Application no: H23/0145/03

Description: Residential development Plots 23 - 46 (revised scheme)

Location: Land off Stockwell Gate
Whaplode

Amendment: Amendment to boundary layout to allow incorporation of land within 'The Pines' (Extract from dwg no. AH2209/001)

EXTRACT FROM DRG. NO: AH2209/001

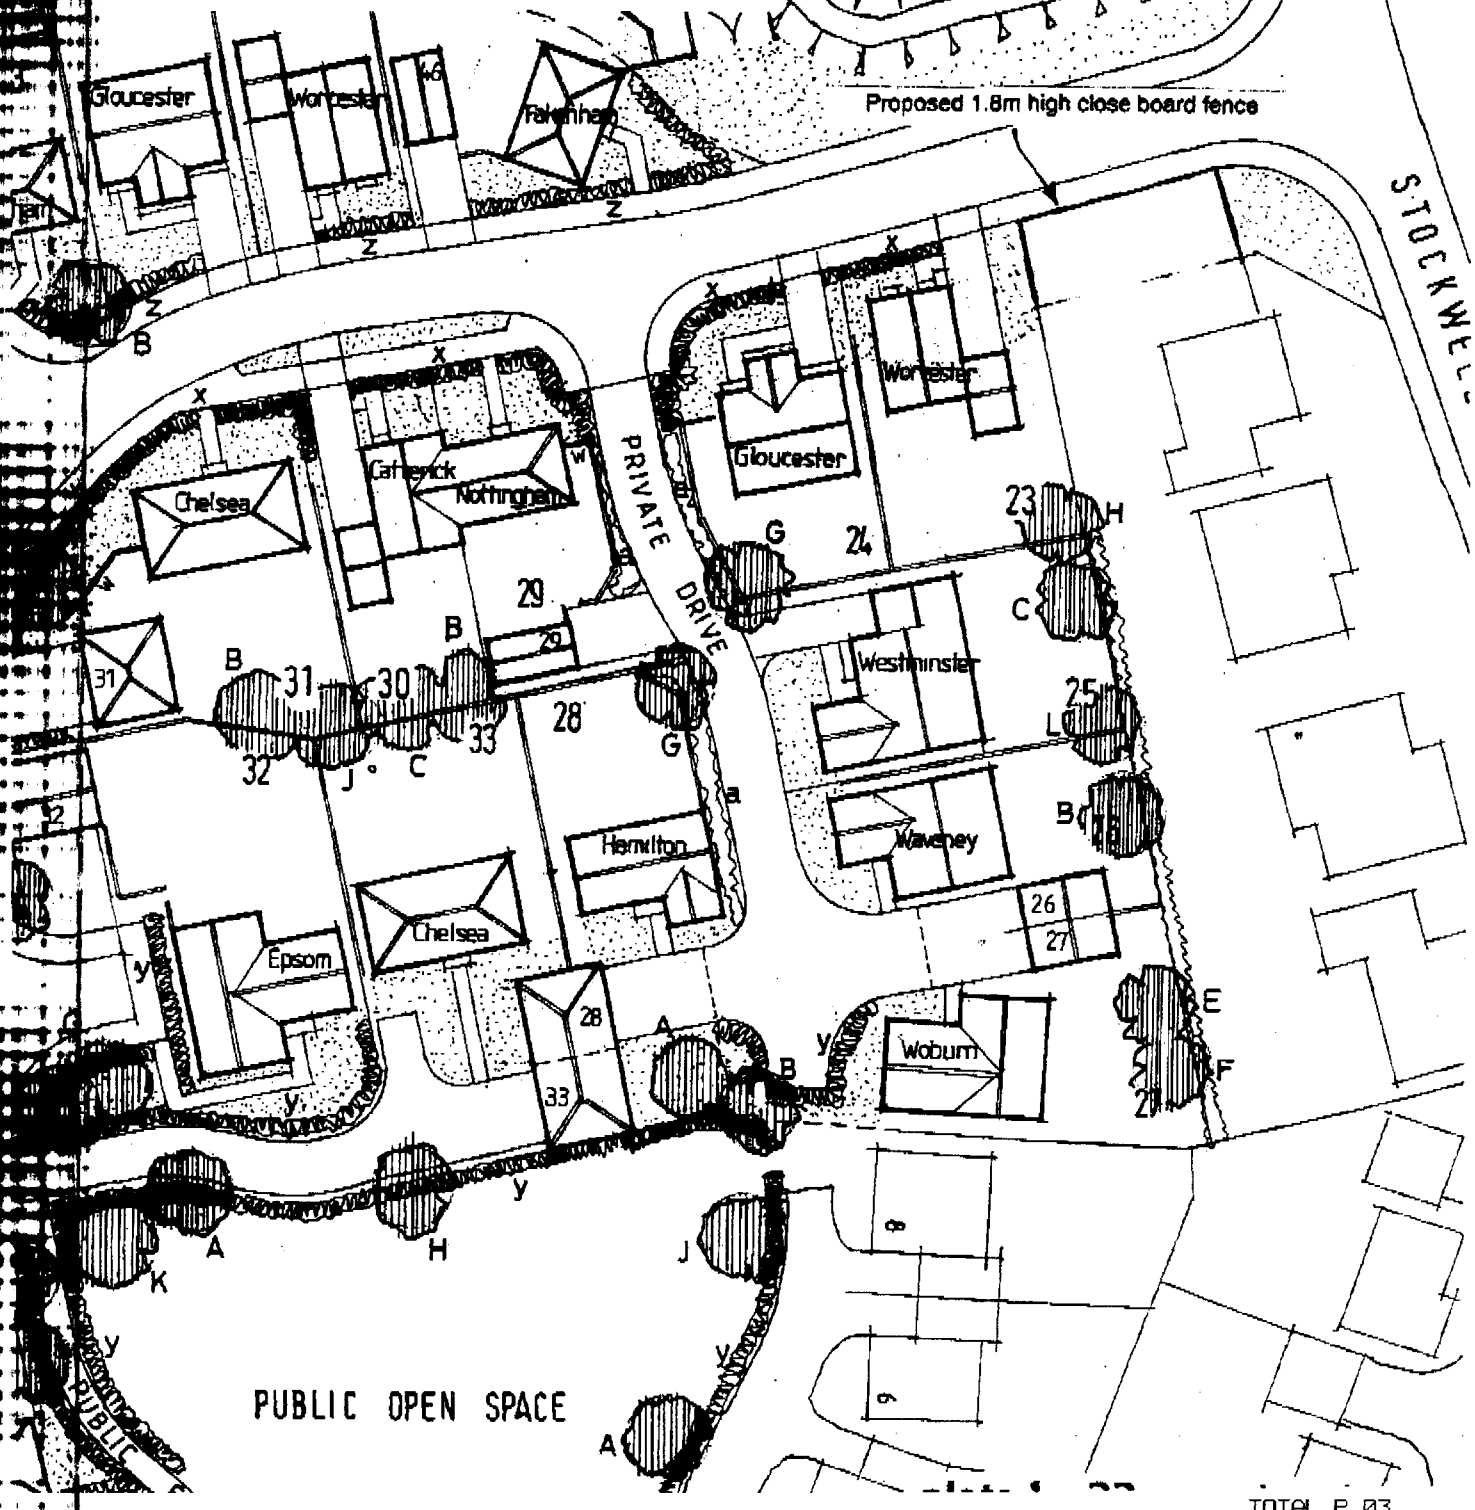
Further to a recent telephone conversation between yourself and Mark Dennis I enclose an extract of the site layout plan to identify a proposed amendment to the boundary arrangement adjacent to the existing property on Stockwell Gate known as the Pines.

We have been in discussion with the owner of this property and the potential for inclusion of the small area of land to the left of the estate access within his curtilege. This additional land would enable this resident to improve his foul drainage system which is presently by septic tank. As presently approved this area would be open land but would not be adopted by the District Council, it could therefore become a potential overgrown eyesore and would certainly be subjected to litter and dog fouling.

The intention is to enclose this area by means of a 1.8m high closeboard fence and given that the approach into the site is ' open ' to the right hand side I do not consider this amendment to be detrimental to the overall appearance of the site.

I therefore seek your agreement that this can be accepted as a minor amendment to the scheme.

The amended details submitted in respect of the above proposal have been received and I consider that the changes are too significant to be treated merely as a amendment. A fresh application will therefore be required (forms enclosed). This does not imply that permission will or will not be forthcoming for any such revised application.
